4-1 – 12

Proposed Change as Submitted

Committee Action

FIG. 403.5.1 (c)

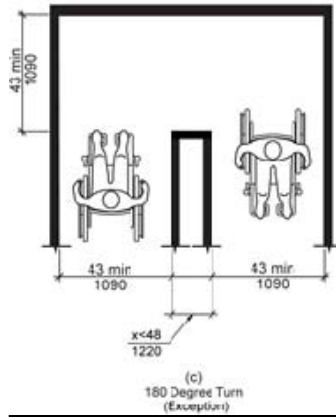
1. Section 403.5.1 shall not apply where the clear width during the turn is 60 inches (1525 mm) minimum.
2. Section 403.5.1 shall not apply where a minimum clear width of 43 inches (1090 mm) is provided approaching, during, and leaving the turn.

403.5.2 Passing Space. An accessible route with a clear width less than ~~60~~ 64 inches (~~1525~~ 1625 mm) shall provide passing spaces at intervals of 200 feet (61 m) maximum. Passing spaces shall be either a 60-inch (1525 mm) minimum by ~~60-inch~~ 64-inch (~~1525~~ 1625 mm) minimum space, or an intersection of two walking surfaces that provide a T-shaped turning space complying with Section 304.3.2, provided the base and arms of the T-shaped space extend ~~48~~ 54 inches (~~1220~~ 1360 mm) minimum beyond the intersection.

403.5.2 Passing Space. An accessible route with a clear width less than 60 inches (1525 mm) shall provide passing spaces at intervals of 200 feet (61 m) maximum. Passing spaces shall be either a 60-inch (1525 mm) minimum by 60-inch (1525 mm) minimum space, or an intersection of two walking surfaces that provide a T-shaped turning space complying with Section 304.3.2, provided the base and arms of the T-shaped space extend ~~48~~ 52 inches (~~1220~~ 1220 mm) minimum beyond the intersection.

Committee Reason: The Committee agreed to a revised clear floor space of 30 by 52 inches in Proposal 3-13-12. The original proposal here assumed a larger clear floor space, therefore the Committee approved only changes needed to address the 30 by 52 dimensions. Changes to Section 403.5.1 were not approved because the Committee felt the changes approved in proposal 4-8-12 were more appropriate.

FIG. 404.2.2
CLEAR WIDTH OF DOORWAYS

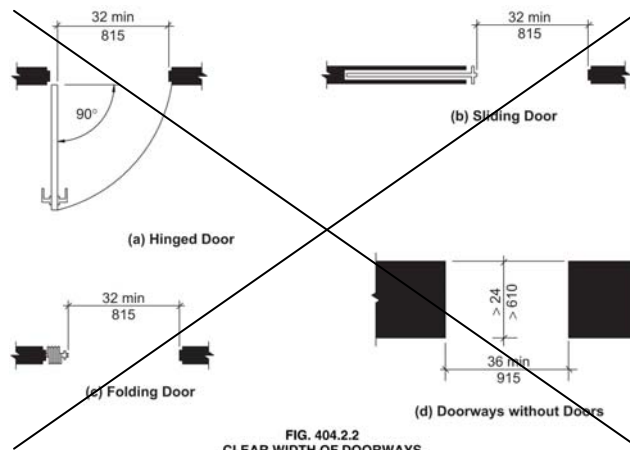
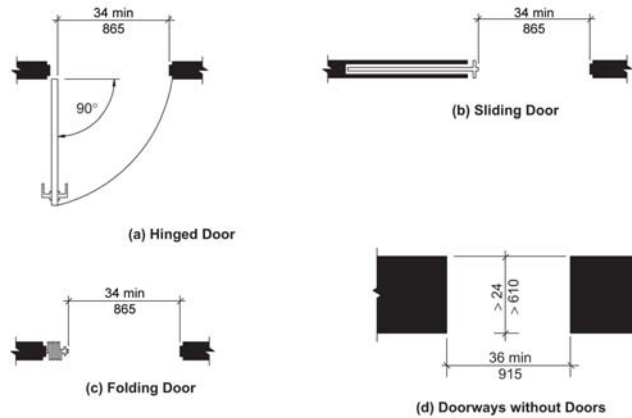
404.2.2 Clear Width. Doorways shall have a clear opening width of ~~32~~ 34 inches (~~815~~ 865 mm) minimum. Clear opening width of doorways with swinging doors shall be measured between the face of door and stop, with the door open 90 degrees. Openings more than 24 inches (610 mm) in depth at doors and doorways without doors shall provide a clear opening width of 36 inches (915 mm) minimum. There shall be no projections into the clear opening width lower than 34 inches (865 mm) above the floor. Projections into the clear opening width between 34 inches (865mm) and 80 inches (2030 mm) above the floor shall not exceed 4 inches (100 mm).

Reason: Many of the technical requirements of the ICC/ANSI A117.1 (2009) Accessible and Usable Buildings and Facilities (ICC/ANSI) designed to accommodate wheeled mobility users are based on research completed from 1974 to 1978 using a research sample that included about 60 individuals who used manual wheelchairs (Steinfeld et al., 1979).

The following is Figure 404.2.3.2(e) from the A117.1-2009 standard.

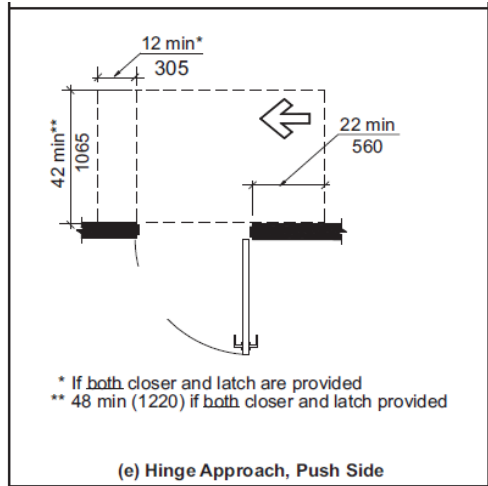
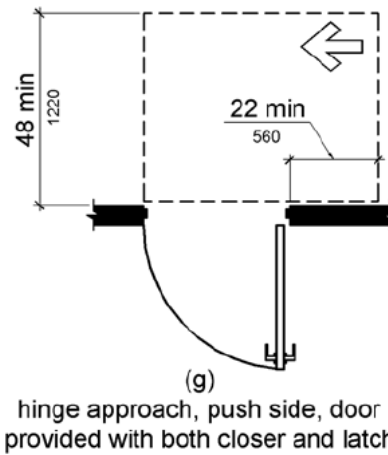
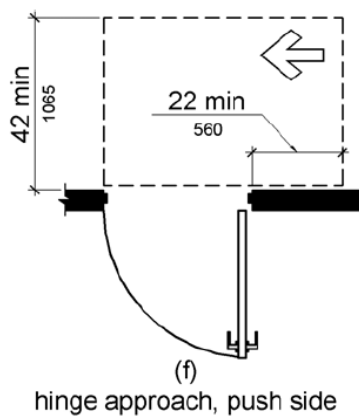
The A117.1 requires there 12 inches beyond the latch side on this door if both a closer and a latch are provided on the door. The ADA does not have this 12 inch requirement.

This requirement was added to the A117.1 standard between the 1998 and 2003 editions by proposal 4-015 and was modified by public comment that cleaned up the footnote reference for it. The proponent's reason statement said that figure (b) the front approach push side and figure (e) the hinge approach push side are similar situations and that having the 12 inches on the forward approach should also be provided on the hinge approach.

Because this extra requirement creates a discrepancy between the A117.1 and ADA which is not readily apparent and well known, the elimination of the footnote reference would help to coordinate the two standards and make this basic issue of door maneuvering clearances consistent. It seems that the addition of this requirement was probably not well justified when it was added into the 2003 A117.1 standard and with the change made in Section 404.2.3 of the 2009 edition which prevented door maneuvering clearances from including knee and toe clearance it made the difference between the A117.1 and the federal requirements that much greater. With some of the task groups looking at changing the 'building blocks' which could further affect maneuvering clearances, it would seem that this difference between the two standards should be eliminated or better justification should be provided so that it could be added into the federal requirements and coordinated that way.

The graphic representations of the various layouts are provided to better illustrate the differences. In the 2009 standard it is Fig 404.2.3.2(e) and in the 2010 ADA it is Figure 404.2.4.1(g). See ADA figure 404.2.4.1(f) for base condition.

Figure 404.2.3.2, Table 404.2.3.2, Figure 404.2.3.3(a), Table 404.2.3.3, Table 404.2.3.4, Figure 404.2.3.4, Figure 404.2.3.5 (b), (c)

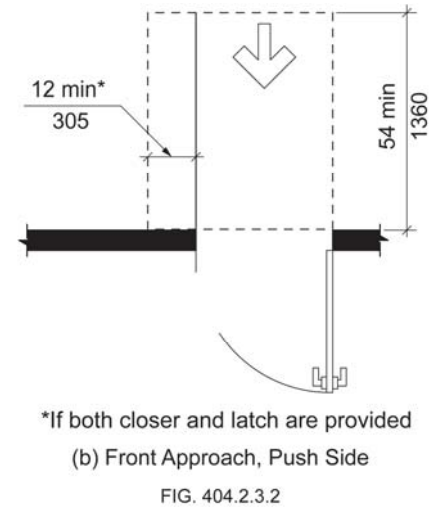
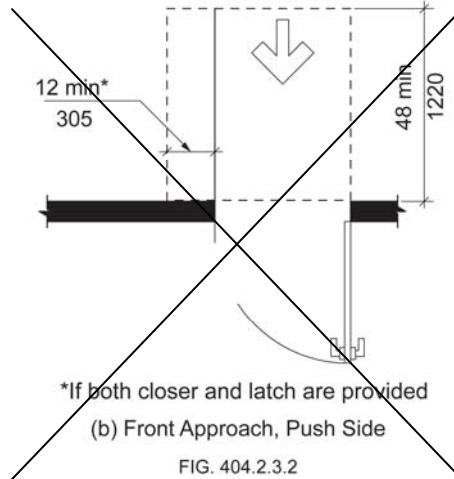
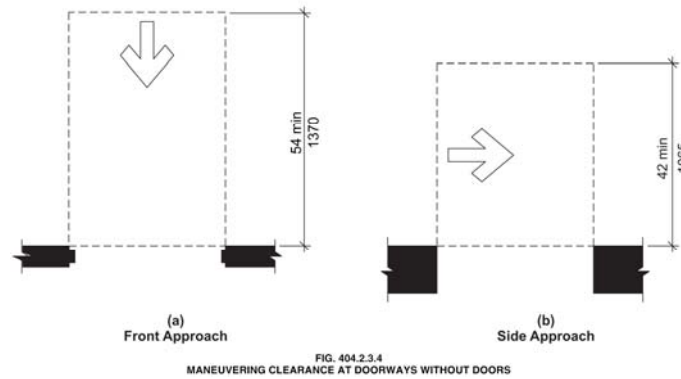
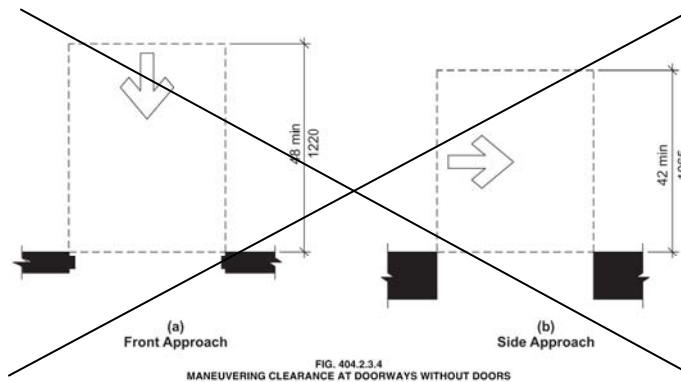
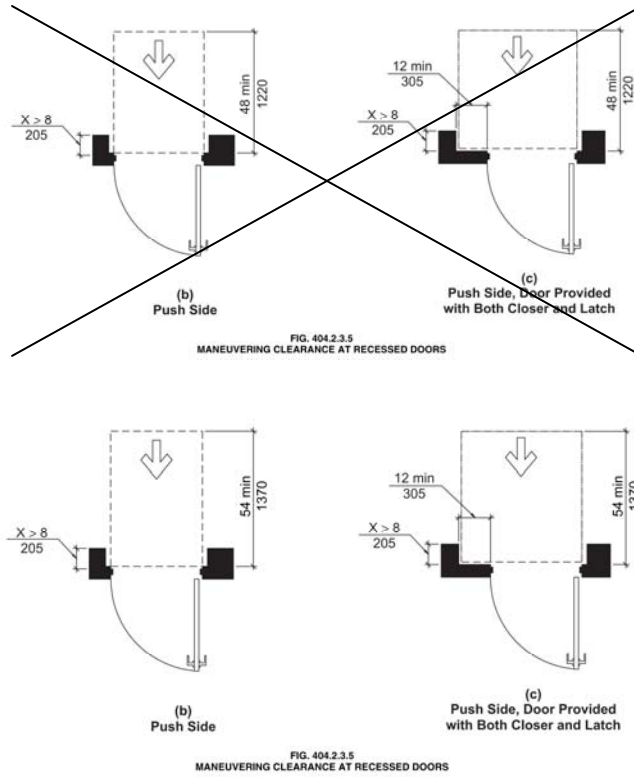
| Approach direction | MINIMUM MANEUVERING CLEARANCES Perpendicular to Doorway |
|--------------------|--|
| From front | 48 54 inches (1220 1370 mm) |

Delete and substitute Figure as follows:

Reason: Many of the technical requirements of the ICC/ANSI A117.1 (2009) Accessible and Usable Buildings and Facilities (ICC/ANSI) designed to accommodate wheeled mobility users are based on research completed from 1974 to 1978 using a research sample that included about 60 individuals who used manual wheelchairs (Steinfeld et al., 1979).

Committee Reason: These revisions reflect the decision in Proposal 3-13-12 to change the length of the clear floor space to 52 inches. Figures will be revised accordingly by the Editorial Task Group.

FIG. 404.2.3.5
MANEUVERING CLEARANCE AT RECESSED DOORS

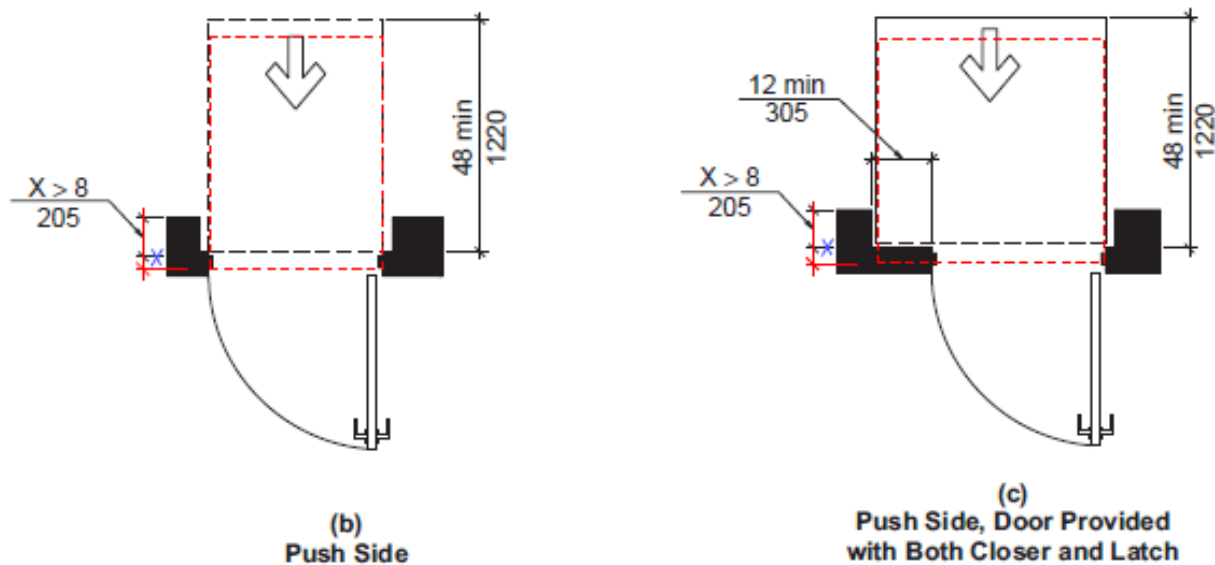
Door recess drawings are not correct. The text indicates that the recess is to be measured from the face of the door but the figures show in two cases the recess measured from the face of the frame.

Reason: When the door is in a frame and the door swings toward you, the face of the door is typically the same as the closest edge of the frame. However, when the door swings away from you, it is on the far side of the frame and the nearest face of the door is already recessed from the edge of the frame. The modified Figure shows the proper method. Although not shown, obviously the 48 inch dimension would need to be revised to show the distance from the face of the maneuvering space to its perpendicular extent.

The revision would show the correct method for assessing recess. This has caused a number of incorrect applications and resulted in doors often being located too far from the face of the adjoining wall.

Revise as the Figure 404.2.3.5 (c) as follows:

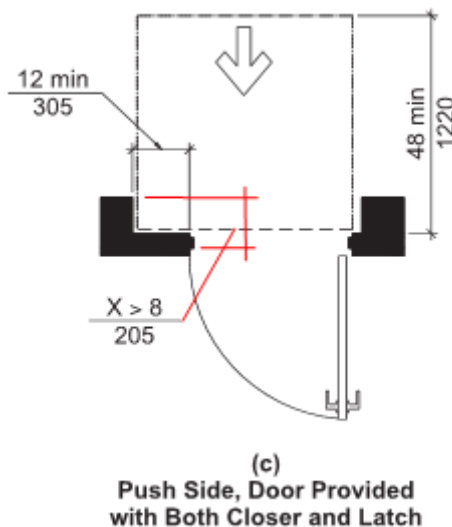
Relocate the arrows and call dimension for the 8 inch depth from the left side of the figure to the location shown below.

Reason: The text for this section states that the dimension is to the "face of the door" measured perpendicular to the "face of the door". The Figure shows the 8" recess from the face of the wall of the door.

The Committee concluded that correcting the figure was editorial and this proposal was referred to the Editorial Task Group.

404.2.5, Figure 404.2.5

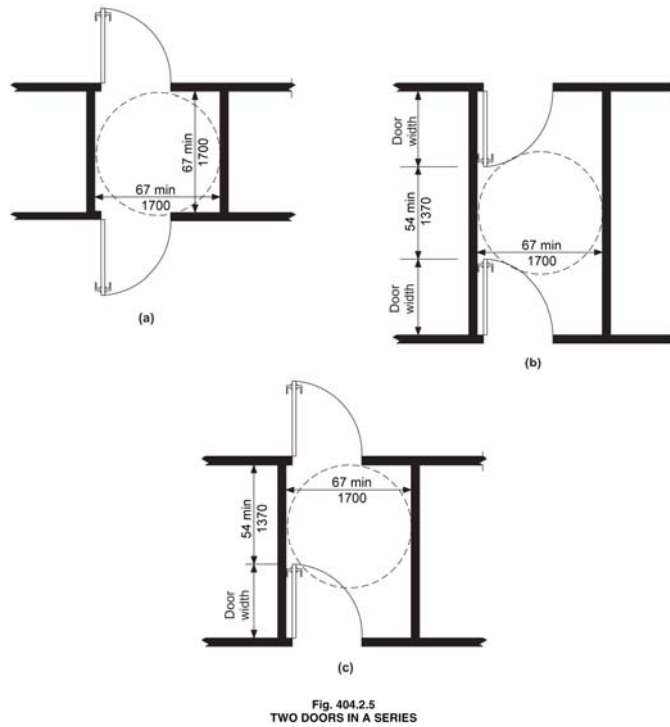
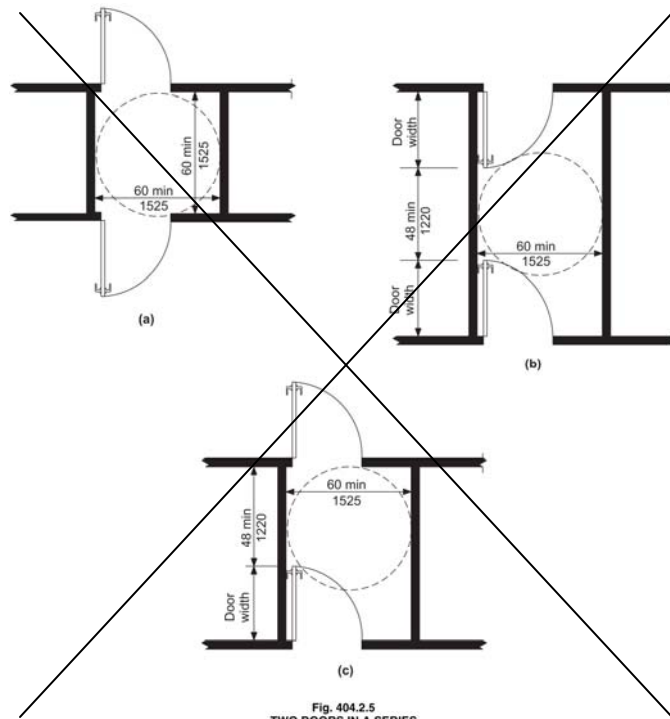
404.2.5 Two Doors in a Series. Distance between two hinged or pivoted doors in series shall be ~~48~~ 54 inches (~~1220~~ 1370 mm) minimum plus the width of any door swinging into the space. The space between the doors shall provide a turning space complying with Section 304.
